## **RESPONSE TO REQUEST FOR INFORMATION: 90-102 REGENT STREET, REDFERN (SSD-10382)**

This correspondence has been prepared by Urbis on behalf of The Trust Company (Australia) Limited ATF Wee Hur Regent Trust (**Wee Hur**) and relates to the above State Significant Development Application (**SSDA**) at 90-102 Regent Street, Redfern.

It responds to a Request for Information (**RFI**) issued by the Department of Planning, Industry and Environment (**DPIE**) on 25 May 2021. DPIE requested a response to the additional submission by the City of Sydney following their review of the Revised Response to Submissions (**RRtS**) report submitted by Wee Hur on 27 April 2021.

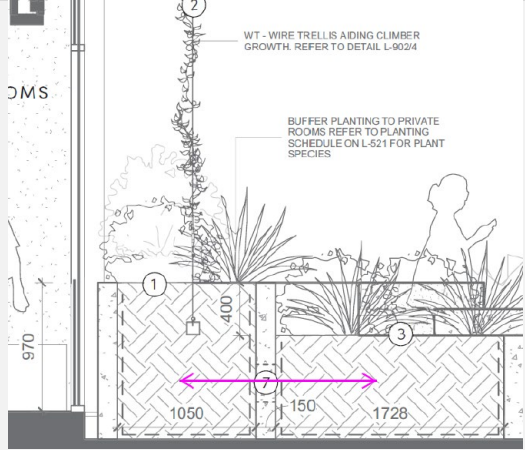
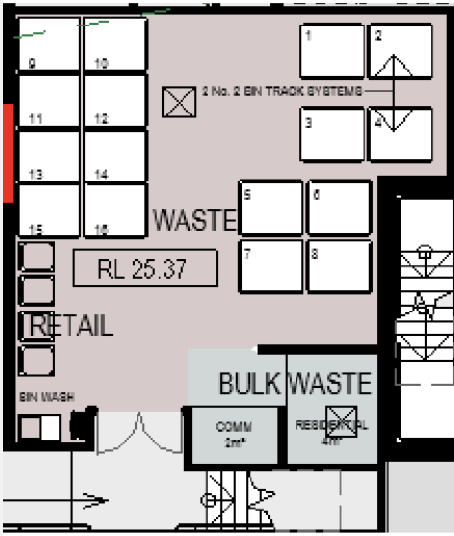
2c	The garden beds proposed on Level two are not large or deep enough to sustain trees and must be amended to provide adequate soil volumes for the planting of trees as laid out within the Sydney Landscape Code. The smaller raised planters should be consolidated and made contiguous to allow for the soil volume and depth that can sustain mature trees.	The Landscape Plans have been updated to raise planters and provide wall cut-outs through back-to-back planters with a 50% permeability ratio to increase shared soil volumes as shown below.

Item	Issues	Action/ Response
		 <p>WT - WIRE TRELLIS AIDING CLIMBER GROWTH. REFER TO DETAIL L-903/4</p> <p>BUFFER PLANTING TO PRIVATE ROOMS REFER TO PLANTING SCHEDULE ON L-921 FOR PLANT SPECIES</p>
2d	<p>The three 'Tristaniopsis laurina – Small' within the Level 3 rooftop must be replaced with one medium sized tree and the rooftop terrace amended to be a garden bed that provides soil volumes consistent with the Sydney Landscape Code.</p>	<p>The Level 3 west facing terrace has been amended and the small planter boxes consolidated to form one in-situ planter which covers the entire rooftop area with a soil depth of 1m. The three Tristaniopsis laurina trees have been replaced by one Stenocarpus sinuatus (Firewheel Tree), expected to reach a height of between 8-10m. These changes have been reflected in the updated Landscape Plans at <b>Appendix B</b>.</p>
2e	<p>The limited detail on the glass canopy over the communal open space means that the stated gaps, which are necessary to allow heat to escape, is not confirmed. This detail, and the subsequent viability of the planting, remains in question. Substantially, more detail is required to confirm the viability of the landscape proposal, however given the lack of clarification to this point, this should be done to the satisfaction of DPIE.</p>	<p>The supplementary response provided by Turf Design confirms adequate airflow and natural irrigation can be provided to the planter areas to supplement the automatic subsurface drip irrigation system. The glass awning will also allow adequate natural light to the planter areas.</p>
